Our Ref. GB/AS/1588/IR

World Heritage List 2019

Bagan (Myanmar) – Interim report and additional information request

Figure 1: Component 6 showing area to northeast containing the foundations of the monks' house. If this component is included within the property (should it be inscribed on the World Heritage List), this additional area should be considered for inclusion.

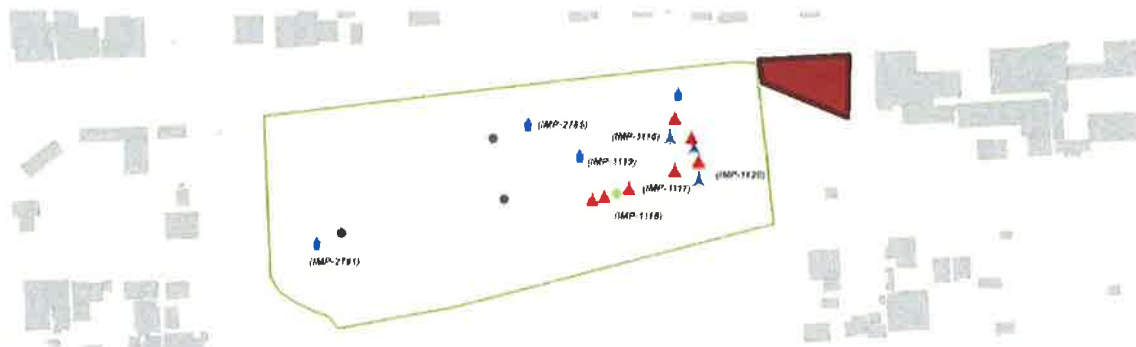
The ICOMOS Panel would suggest that if Component 6 remains as part of the nomination, it would be appropriate to adjust the boundary to incorporate this feature. An indicative outline of the additional area is shown below, but ground-truthing should occur if the boundary adjustment is to be made.
